DEPARTMENT OF TRANSPORTATION

Contract #: 04-0120F4Cty: SF/ALA Rte: 80 PM: 13.2/13.9File #: 99.28**WELDING INSPECTION REPORT****Resident Engineer:** Pursell, Gary**Address:** 333 Burma Road**City:** Oakland, CA 94607**Report No:** WIR-012333**Date Inspected:** 24-Feb-2010**Project Name:** SAS Superstructure**OSM Arrival Time:** 645**Prime Contractor:** American Bridge/Fluor Enterprises, a JV**OSM Departure Time:** 1845**Contractor:** Zhenhua Port Machinery Company, Ltd (ZPMC) Chanxing Island**Location:** Shanghai, China

CWI Name:	N/A	CWI Present:	Yes	No
Inspected CWI report:	Yes No N/A	Rod Oven in Use:	Yes No N/A	
Electrode to specification:	Yes No N/A	Weld Procedures Followed:	Yes No N/A	
Qualified Welders:	Yes No N/A	Verified Joint Fit-up:	Yes No N/A	
Approved Drawings:	Yes No N/A	Approved WPS:	Yes No N/A	
		Delayed / Cancelled:	Yes No N/A	
Bridge No:	34-0006	Component:	OBG Segment 10BE

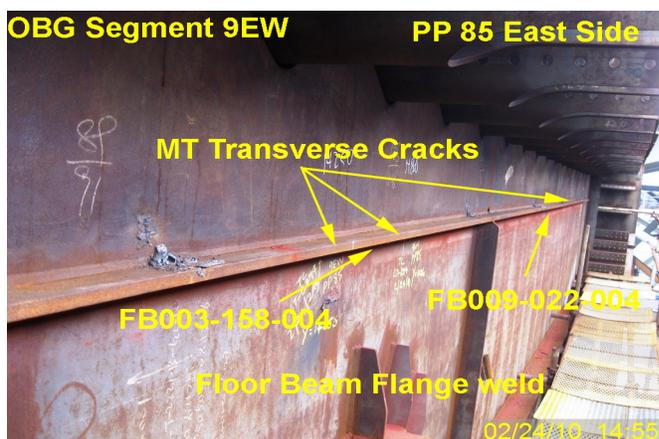
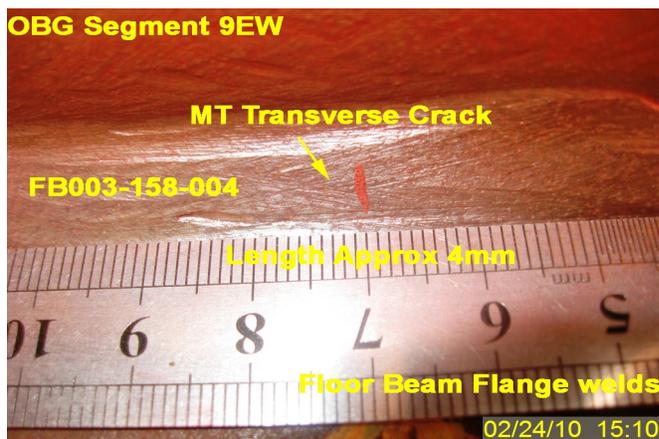
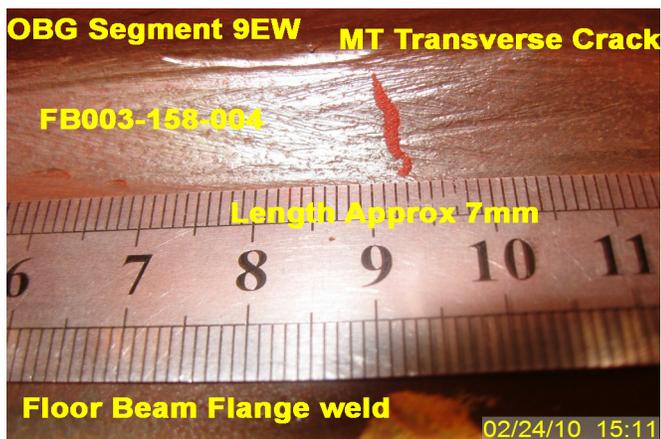
Description of Incident: During random Quality Assurance Visual review of welds located on segment 9EW, this Quality Assurance Inspector (QA) discovered three (3) Transverse linear indications measuring approximately 4mm, 6mm & 7mm in lengths. The indications were discovered visually and confirmed by Magnetic particle Testing (MT) by Caltrans QA. ZPMC Quality Control MT Technicians claimed that magnetic particle testing have been performed on these welds that require 25% MT. The indication is clearly marked on the material near the weld. The welds are identified as FB003-158-004 and FB009-022-004. The panel point is identified as a PP85. This weld is a Fillet weld joining the Floor beam Web to Flange. The Floor Beam Flange weld is identified as Non SPCM. For further information, please see the attached pictures
